**Re: Seven Bar Ph 2 and 3 Entry Drive Grading and Drainage Plan  
Engineer's Stamp dated 11-20-09 (A13/D002)**

| <p>TITLE: <b>7 BAR PHASE 2 &amp; 3 ENTRY DRIVE</b><br/> <i>GRADING &amp; DRAINAGE PLAN</i></p>  |  |                        |  |              |             |   |             |  |

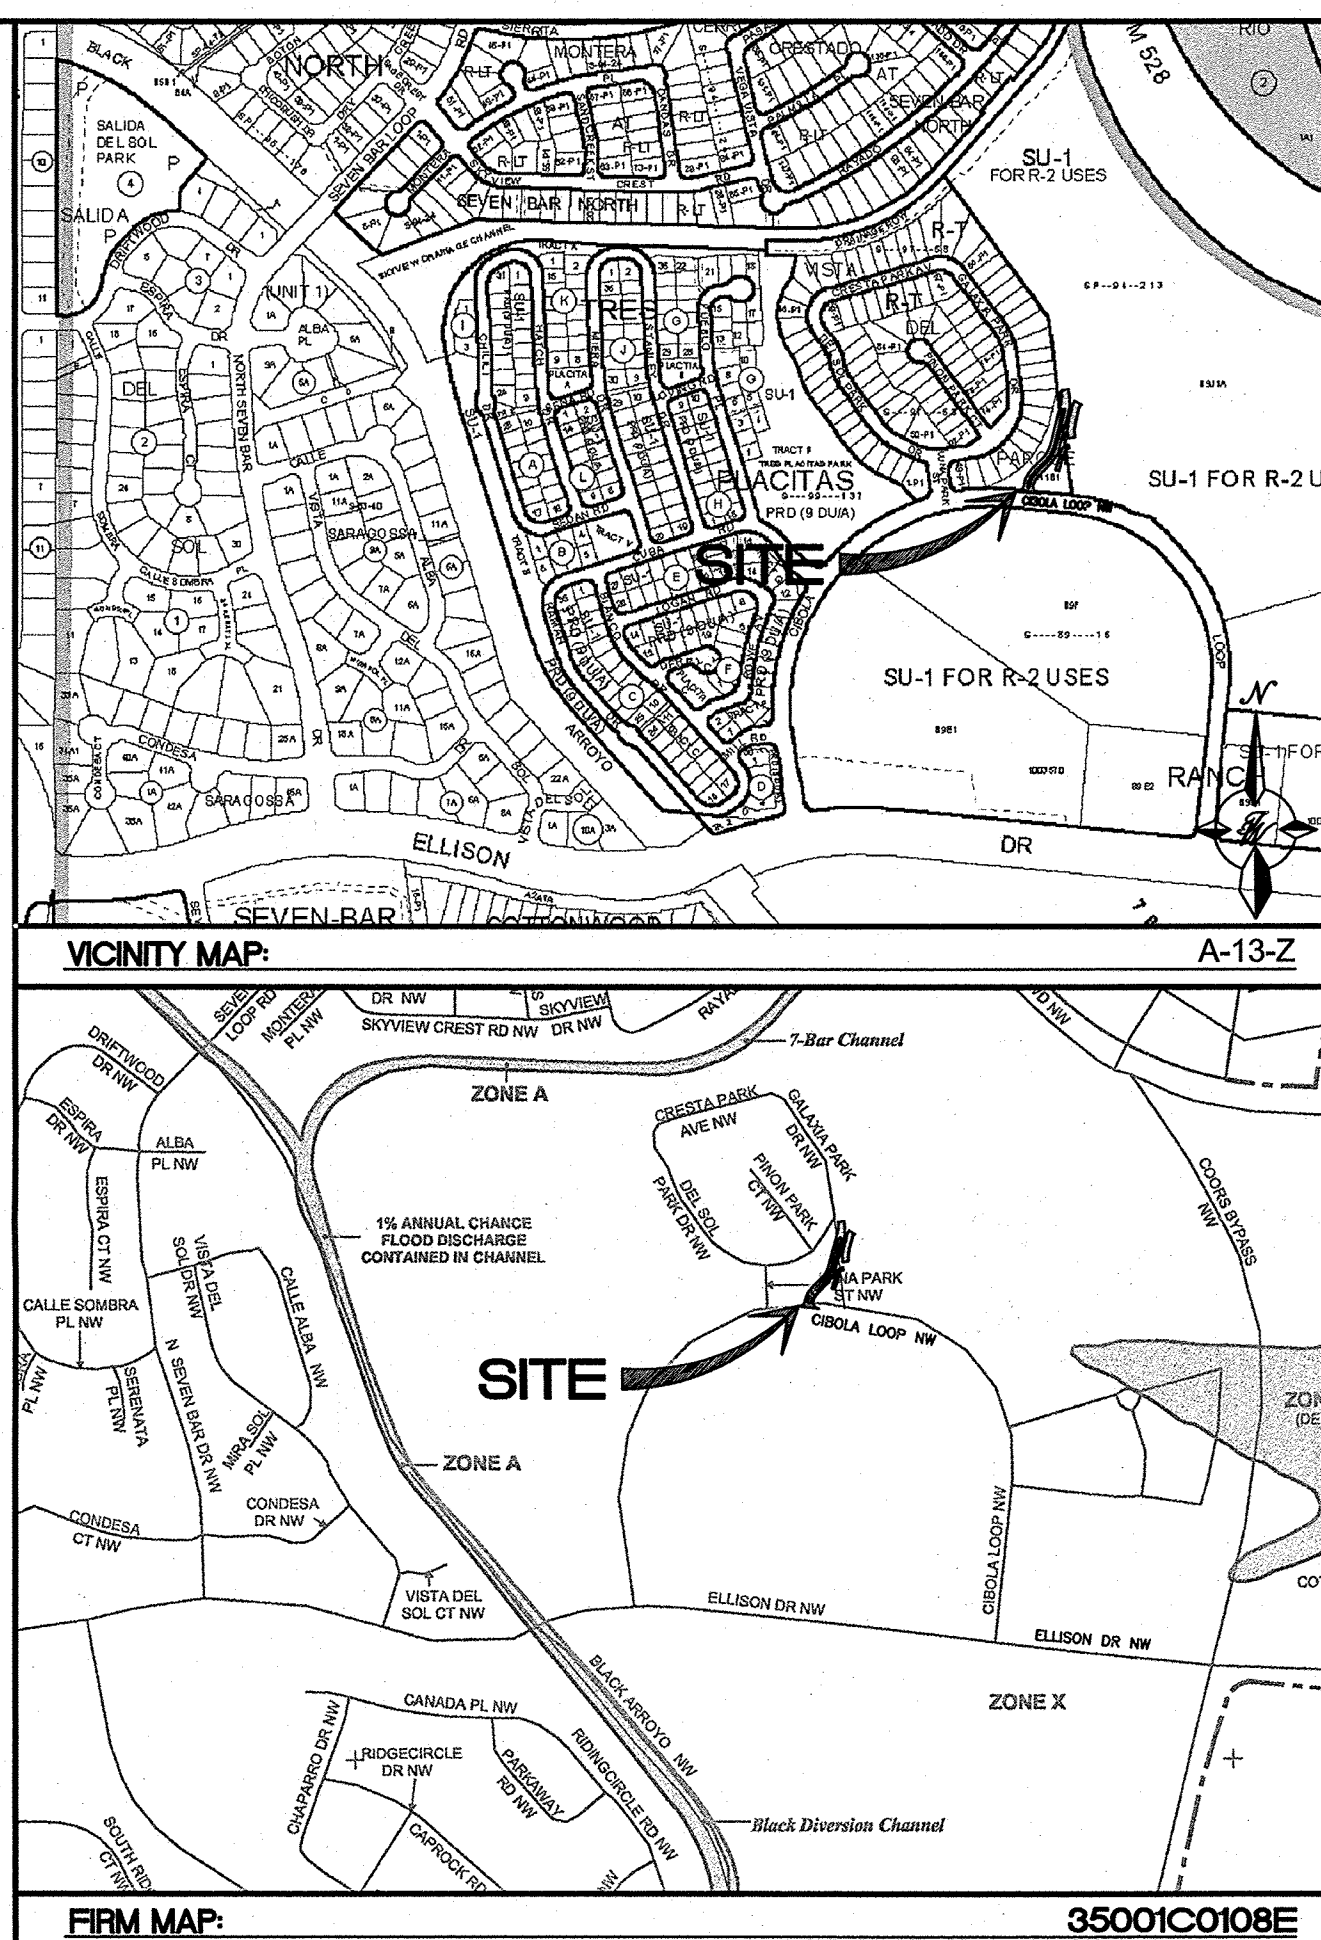
- An encroachment agreement and access easement are required for the new drive. The drive will not be Right-of-Way as shown on the plan.
- The Site Plan will have to be amended.
- The plans to modify the pond will go through the Work Order process.
- More detail will be required on the construction drawings.
